## **20.3 Questions/Responses**

### **20.3.1 Response to First RAI — Reference 1**

**Figure 20.3.2-1 Isolation Valve Arrangement of Standby Liquid Control System Line (Response to Question 430.40)**

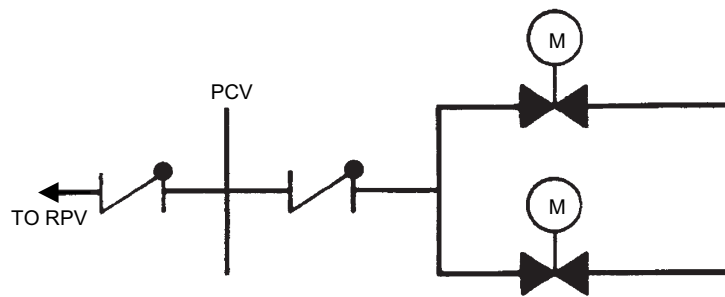
With respect to Figure 5.2-38a:

The standby liquid control system will be added to the next revision of Figure 6.2-38a. The valve configuration is shown in Figure 20.3.2-1.
